SAN FRANCISCO PLANNING DEPARTMENT

Memo to the Planning Commission

Date: September 15, 2011
Case No.: **2010.0367DD**
Project Address: **54-60 PERALTA AVENUE**
Permit Application: 2009.12.31.4050 and 2009.12.31.4052
Zoning: RH-2 (Residential, House District, Two-Family)
Bernal Heights Special Use District
40-X Height and Bulk District
Block/Lot: 5512/029 and 031
Project Sponsor: Reza Khoshnevisan
SIA Consulting Corp.
1256 Howard Street
San Francisco, CA 94103
Staff Contact: Corey Teague – (415) 575-9081
corey.teague@sfgov.org
Recommendation: **Do not take DR and approve the projects as proposed.**

**PROJECT SPONSOR'S SUBMITTAL IN RESPONSE TO REQUEST FOR
DISCRETIONARY REVIEW**

What Changed from the Previous Planning Commission Meeting

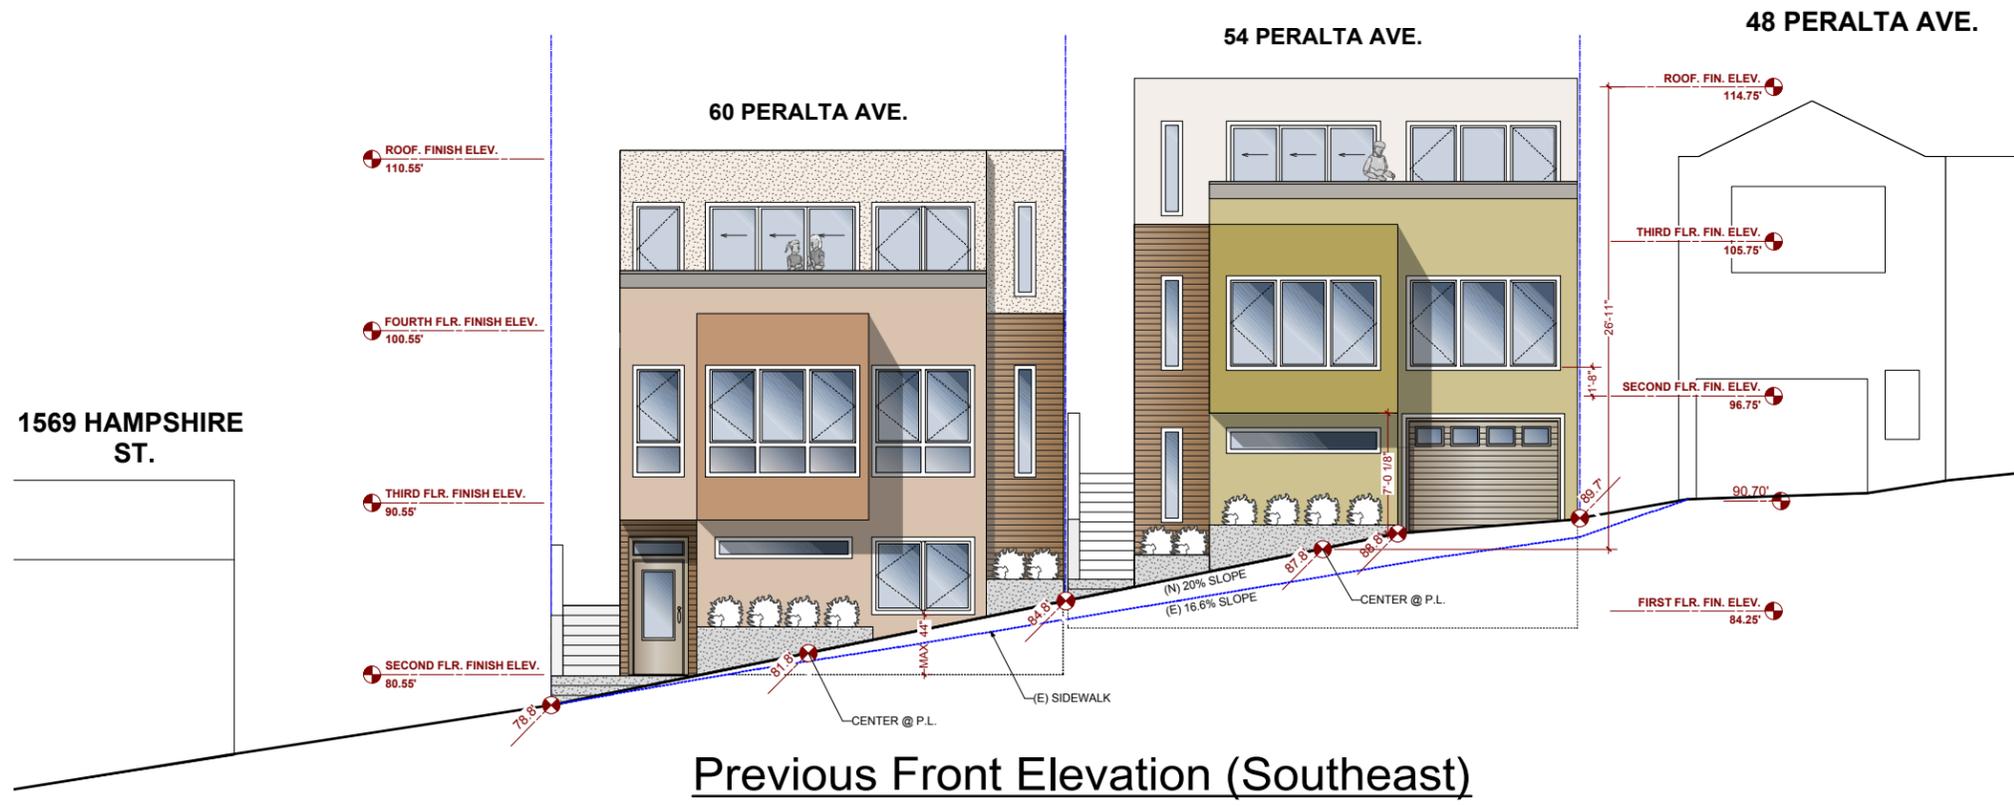
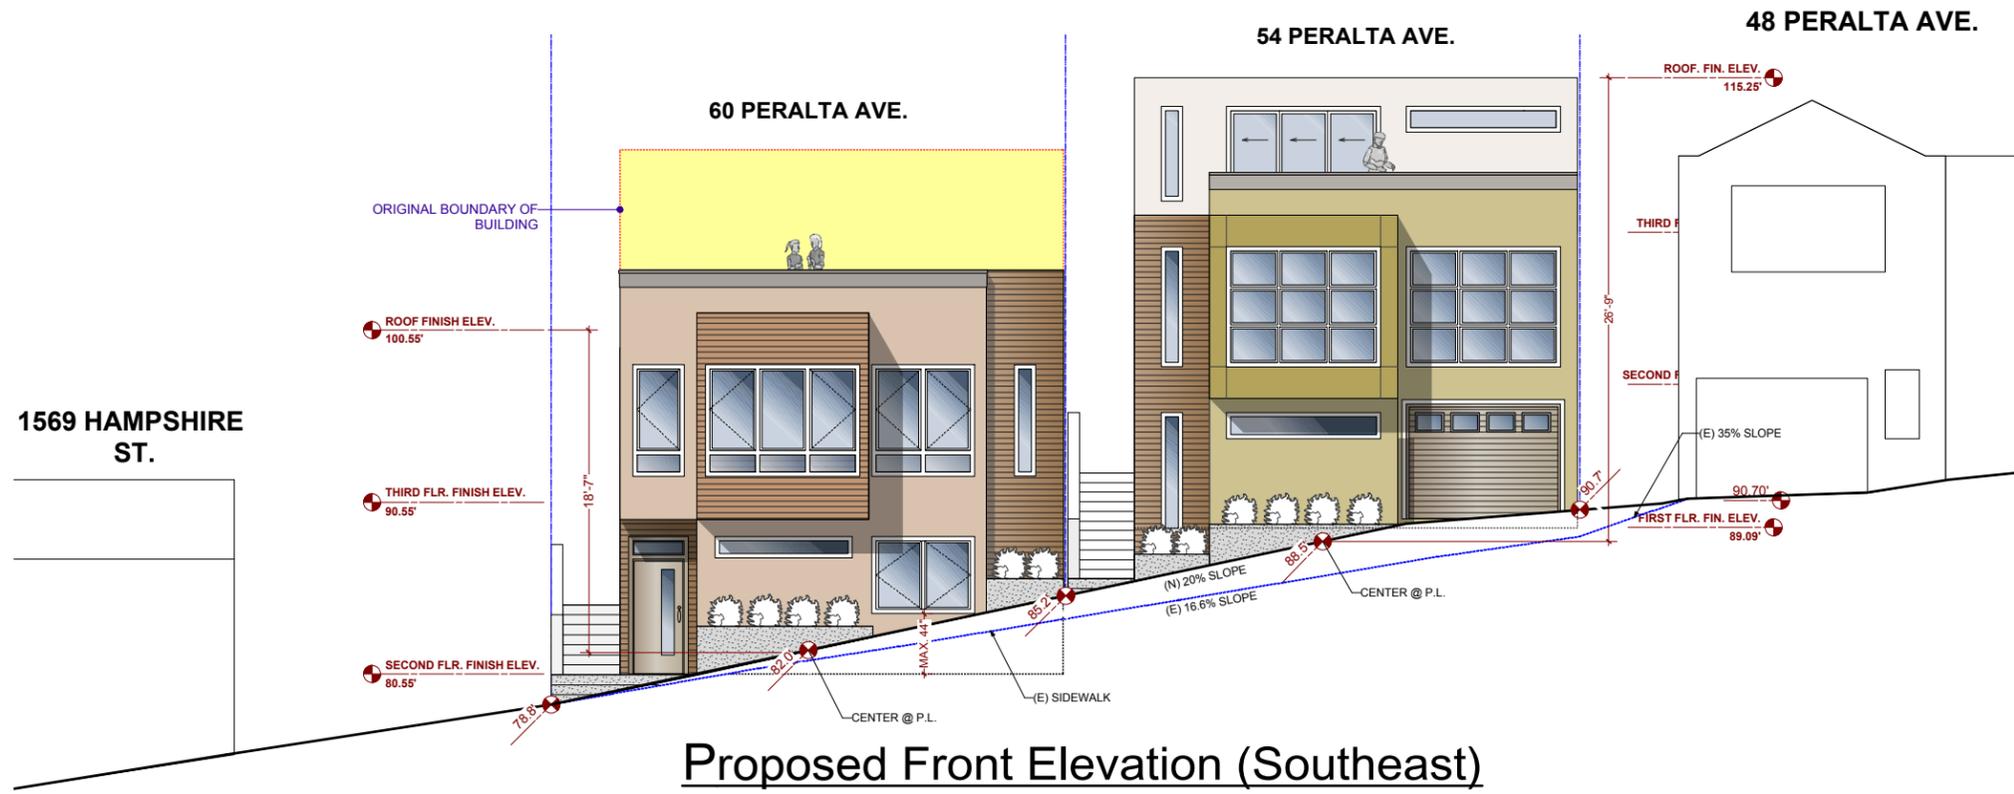
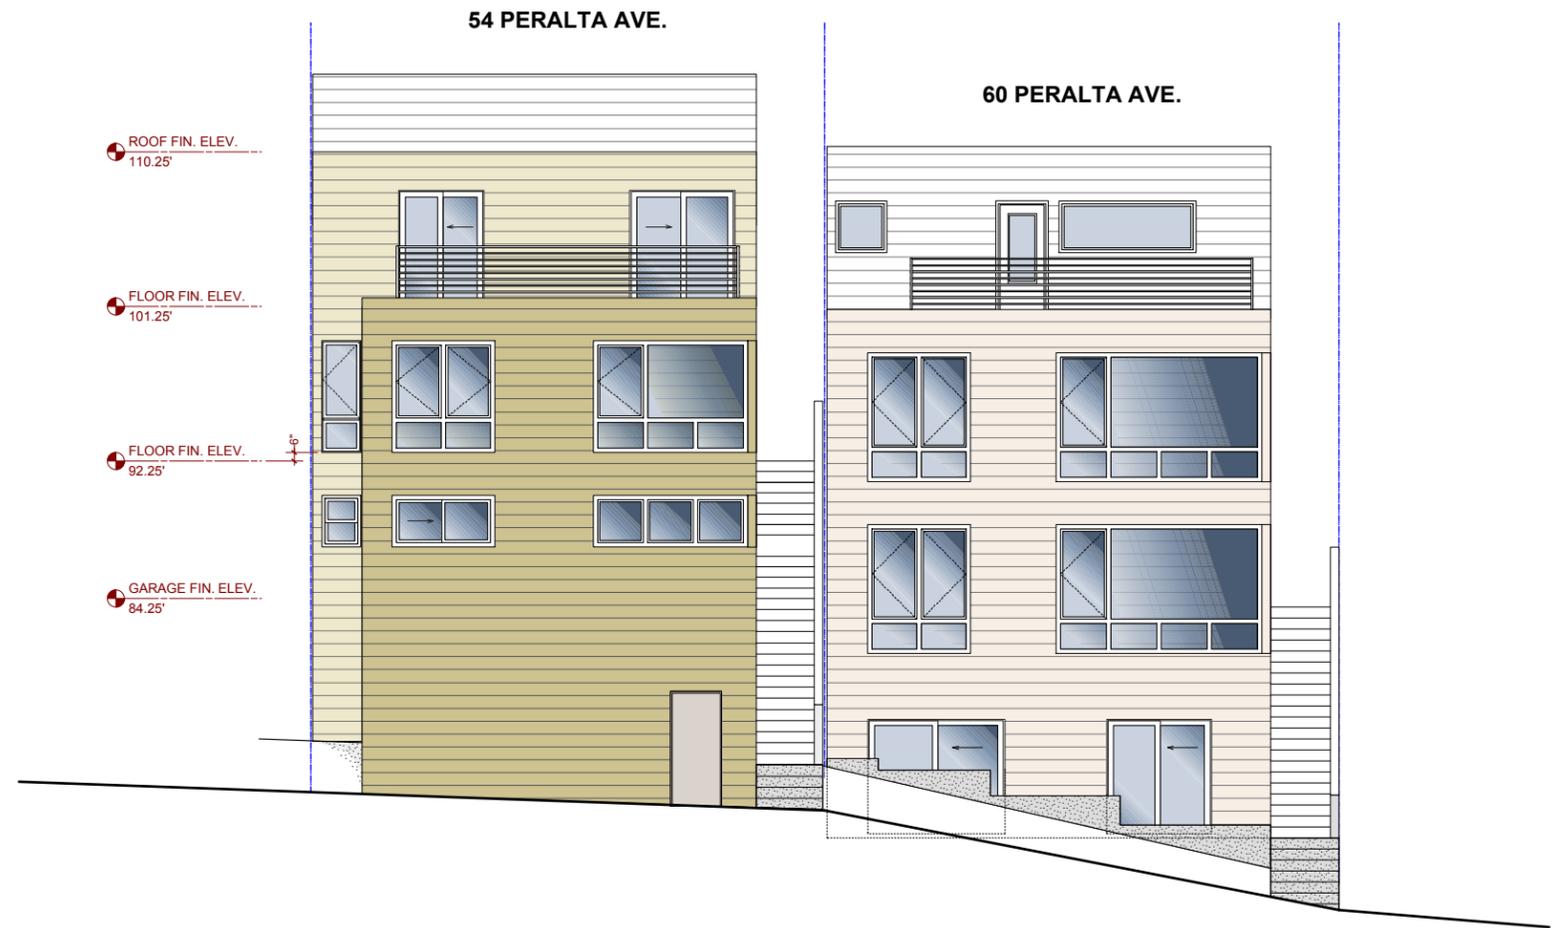
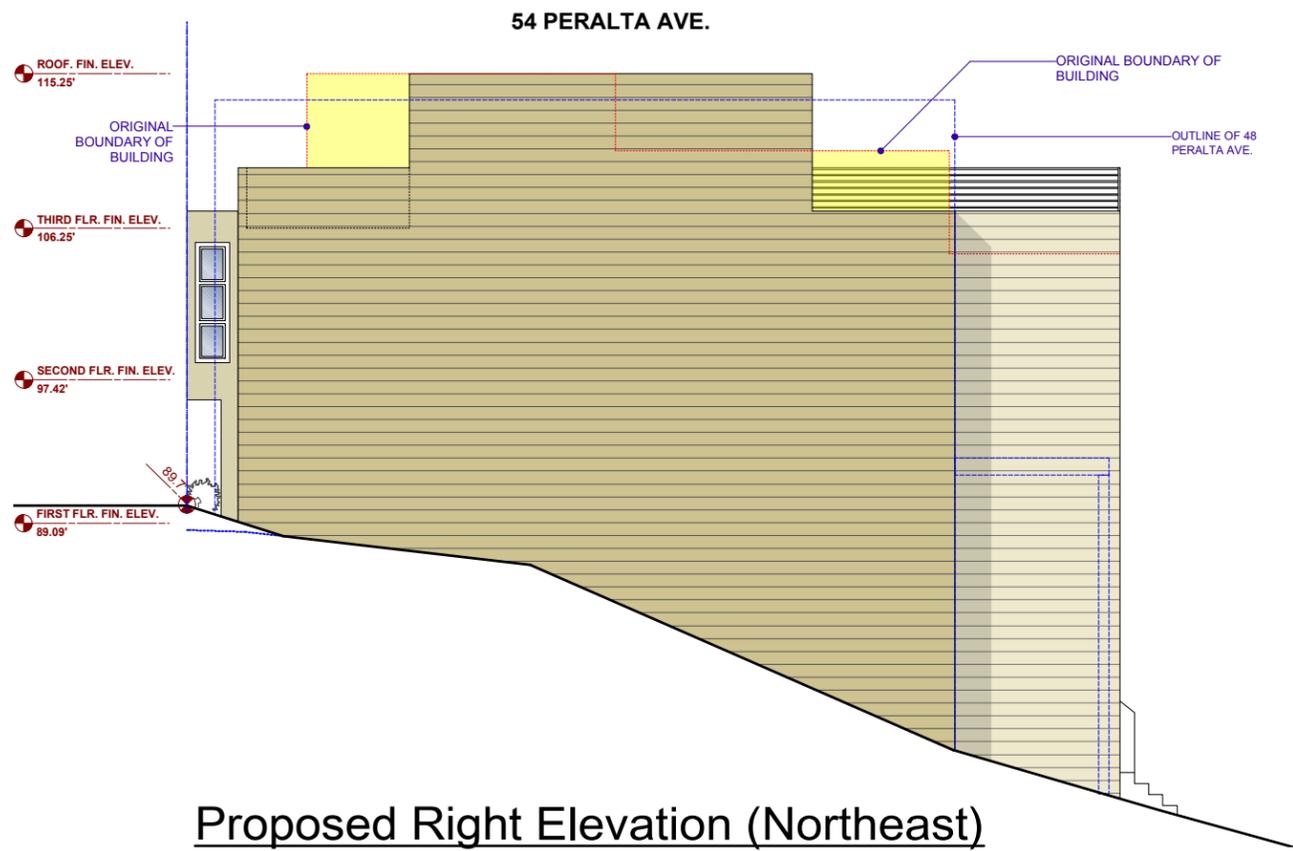
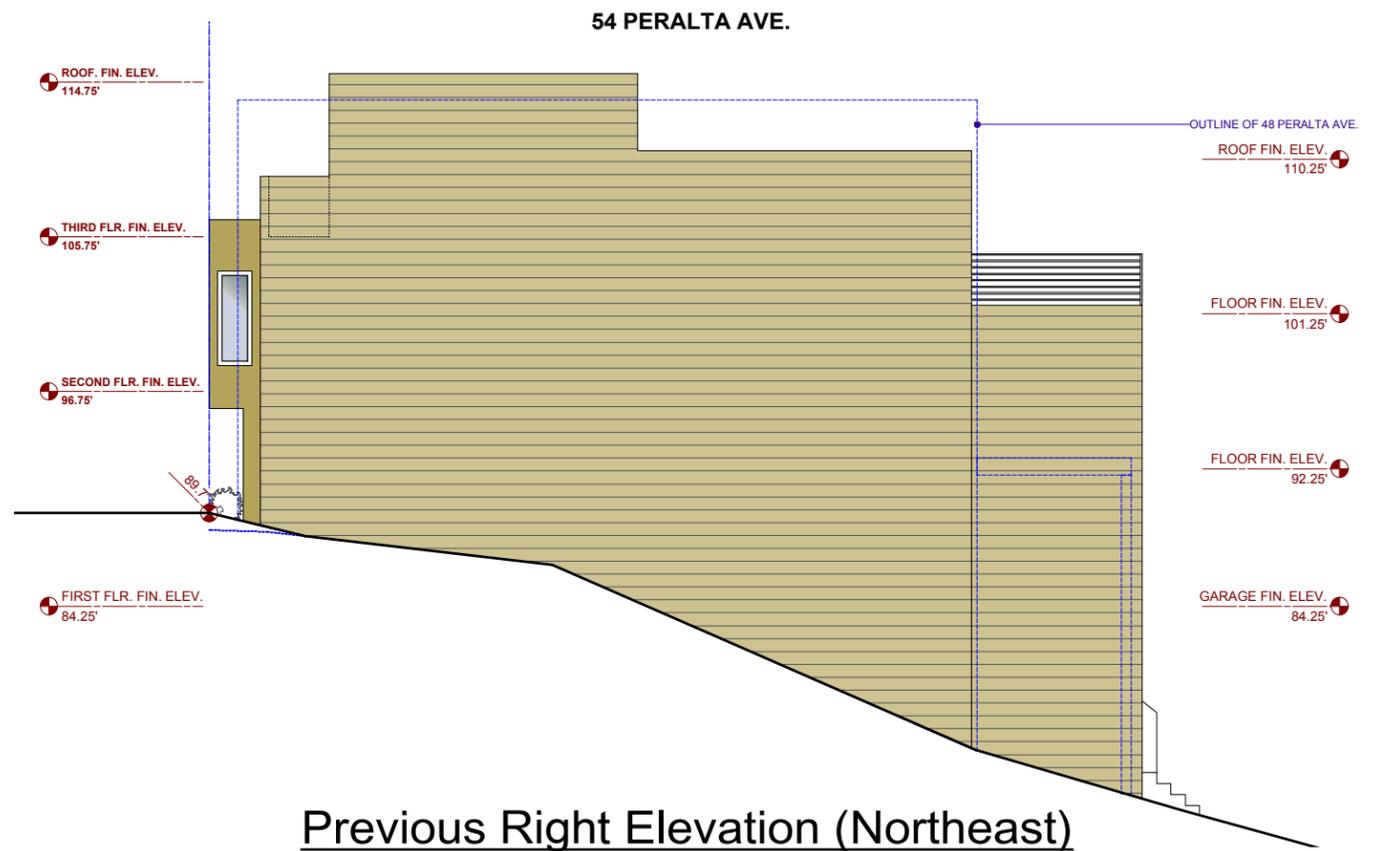
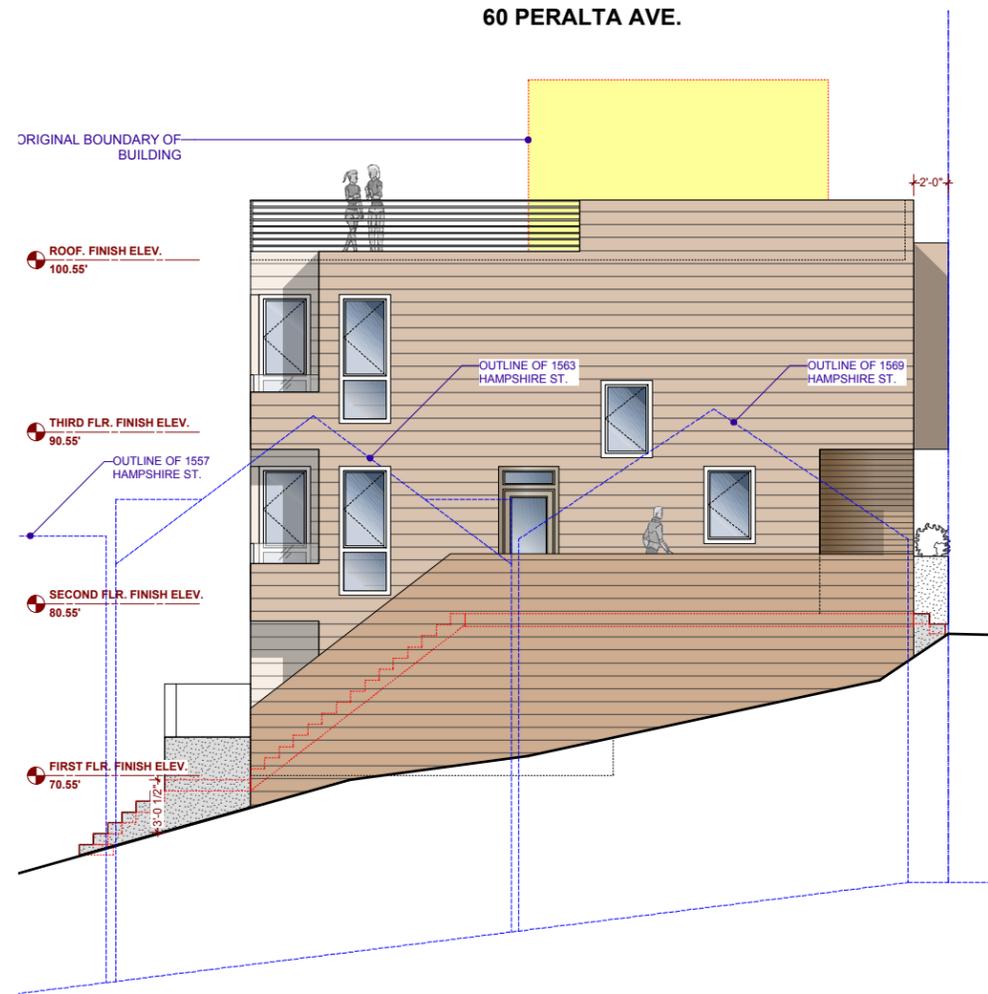
9. Reduced the bulk of the building at 54 Peralta by shortening the top floor. (See Exhibit D).
10. Enhanced lighting at sidewalk level, as per neighbors guidelines, plans to be completed.
